Access Compliance Report

Public Rights-of-Way

Intersection ID: 48557	Main Street: RIDGEFOREST_DR	Cross Street: ARDREY_WOODS_DR	Location: SW
ADA ID: 0453C651E265	Ramp Type: PerpDiag	Initial Pass/Fail: Fail	Overall Compliance: No
Codes/Mitigation Info/Possible Solution		Field Measurements/Component Compliance	
Severity Score: 46.25

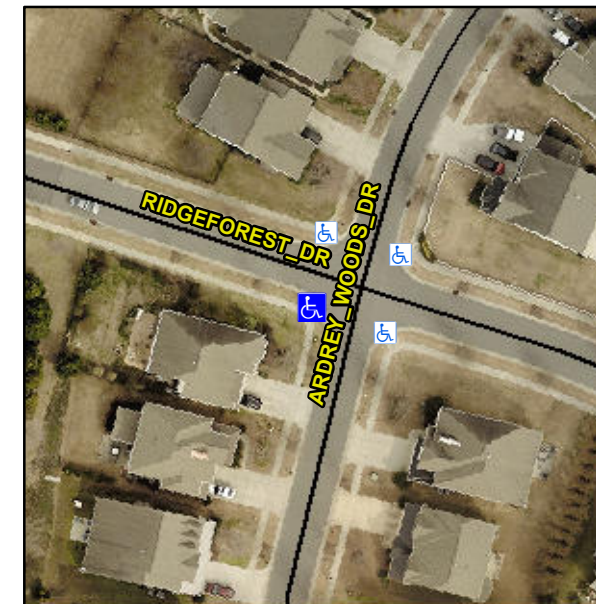
Not Found, R304.5.1, R304.2.2, R304.5.3

Compliance	Description	Data	Compliance	Description	Data
N/A	Ramp Length (in)	74.0	No	Ramp Slope (%)	10.2
No	Ramp Width (in)	47.0	No	Ramp XSlope (%)	9.7
N/A	Flare Type LT	N/A	N/A	Flare Type RT	N/A
N/A	Flare Slope LT (%)	N/A	N/A	Flare Slope RT (%)	N/A
N/A	Flare Traversable LT?	N/A	N/A	Flare Traversable RT?	N/A
N/A	Landing Length (in)	N/A	N/A	DWS Provided?	N/A
N/A	Landing Width (in)	N/A	N/A	DWS Contrast?	N/A
N/A	Landing Slope (%)	N/A	N/A	DWS Length (in)	N/A
N/A	Landing X Slope (%)	N/A	N/A	DWS Full Width?	N/A
N/A	Landing Curb? (Y/N)	N/A	N/A	DWS Offset (in)	N/A
N/A	Shared Landing?	N/A			
N/A	Gutter Ponding?	N/A	N/A	Gutter Slope (%)	N/A
N/A	Gutter Lip Ht (in)	N/A	N/A	Gutter X Slope (%)	N/A
N/A	Painted X Walk1?	No	N/A	Painted X Walk2?	No
	X Walk 1 Direction	To SE		X Walk 2 Direction	To NE
N/A	X Walk 1 Width (in)	N/A	N/A	X Walk 2 Width (in)	N/A
	X Walk 1 Slope (%)	1.5		X Walk 2 Slope (%)	3.3
	X Walk 1 X Slope (%)	3.3		X Walk 2 X Slope (%)	4.2

Remove & Replace Curb Ramp With Two New Directional Ramps or Equivalent.
